November 21, 1984

W3B84-0817  
A4.05

SUBJECT: Waterford 3 SES  
Partial Response to Items  
from Waterford Review Team

LOUISIANA POWER & LIGHT COMPANY		
WATERFORD S.E.S. UNIT NO. 3		
1983-1985 PHASE I INSTALLATION		
NRC CONCERN NO. 7		
STUDY PLAN		
EBASCO SERVICES INC. - FIELD		
SCALE	RELEASED	DATE
D.W. CONSTR.	<i>Richard</i>	FIELD SKETCH
DR. LME	<i>MT</i>	SK. 1504
CH. MT	<i>MT</i>	TABLE 1

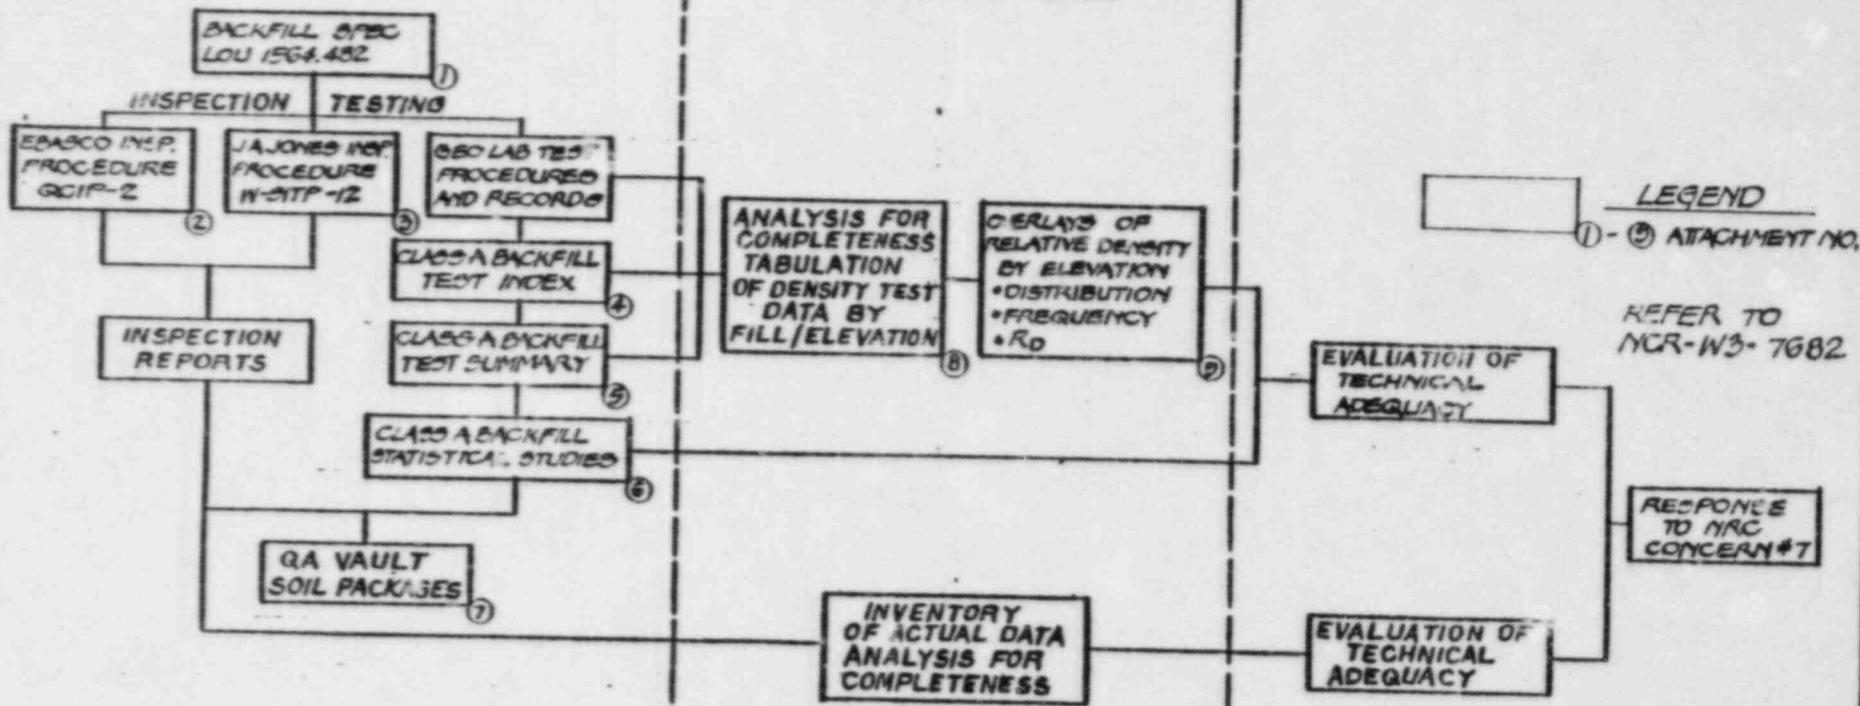
The staff found that records are missing for the in-place density test of backfill in Area 5 (first 5' starting at Elevation -41.25'). These documents are important because the seismic response of the plant is a function of the soil densities.

LP&L shall (1) conduct a review of all soil packages for completeness and technical adequacy and locate all records and provide closure on technical questions, or (2) conduct a review of all soil packages for completeness and technical adequacy and where soil volume cannot be verified by records as meeting criteria, perform and document actual soil conditions by utilizing penetration tests or other methods, or (3) justify by analysis that the soil volumes with missing records, or technical problems as defined after the records review, are not critical in the structural capability of the plant under seismic loads.

In response to the above stated concern, the Ebasco Civil ESSE Department implemented a three stage program to resolve this concern. The review and evaluation of soil test records was conducted in accordance with approach (1) of the concern while the review and evaluation of inspection reports was conducted in accordance with approach (3) of the concern.

The study plan depicted in Table 1 and described herein, was implemented to determine if the deficiencies that do exist in the soil packages will critically effect the structural capacity of the plant under seismic loadings.
